4 Project changes and design refinements

The EIS for the project was prepared based on a concept project design (refer Chapter 5 of the EIS). This design has since been refined to account for design changes and in response to submissions received during exhibition of the EIS.

The Northern Road upgrade -
Mersey Road to Glenmore Parkway
**Construction Boundary and
Compound Sites**

JACOBS NSW SPATIAL - GIS MAP file : IA086100_TNR456_PostEISOperBoundary_EISOperFootprint | 18/10/2017 | DRAWN BY: AA

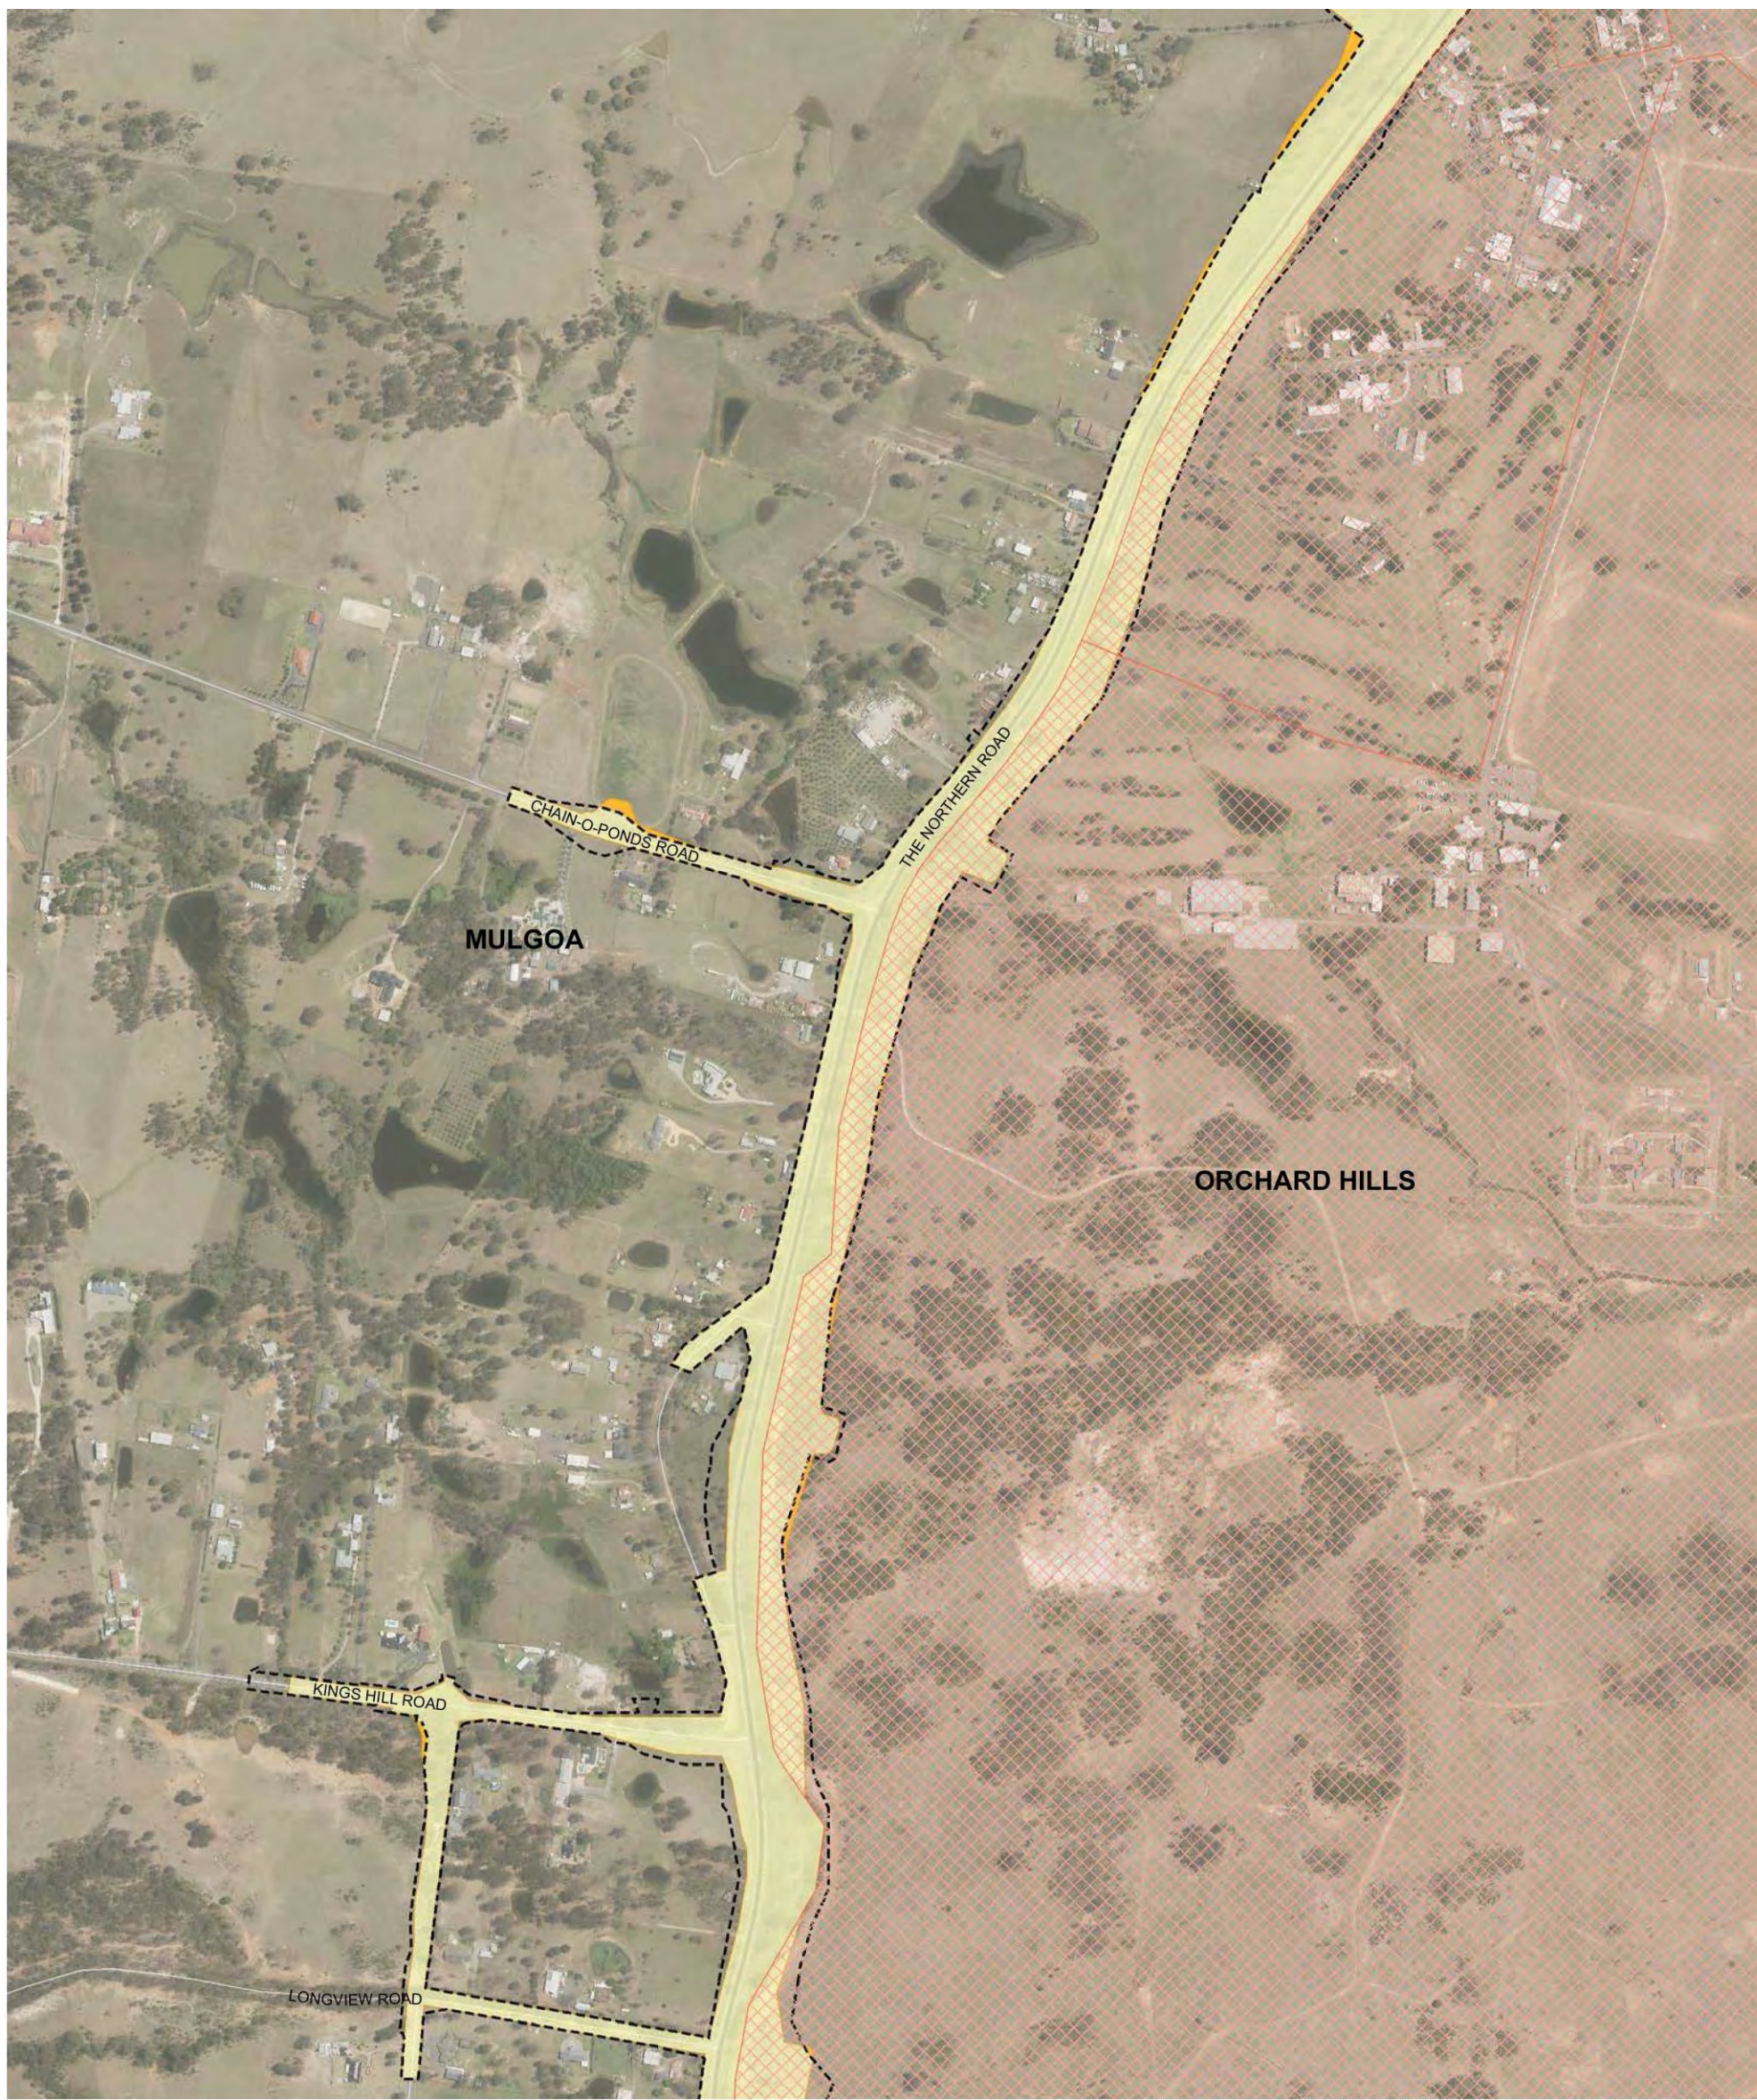
Table 4-2 provides a comparison of the construction and operational footprints calculated for the design refinements against the footprints assessed in the EIS, with reductions of 10 ha and 16 ha identified respectively. An error in the EIS footprint calculations (EIS – original) was identified during the footprint assessment which has been corrected in the table (EIS – revised).

Figure 4-2 provides a comparison of the EIS and the refined design construction footprints. Figure 4-3 provides a comparison of the EIS and the refined design operational footprints.
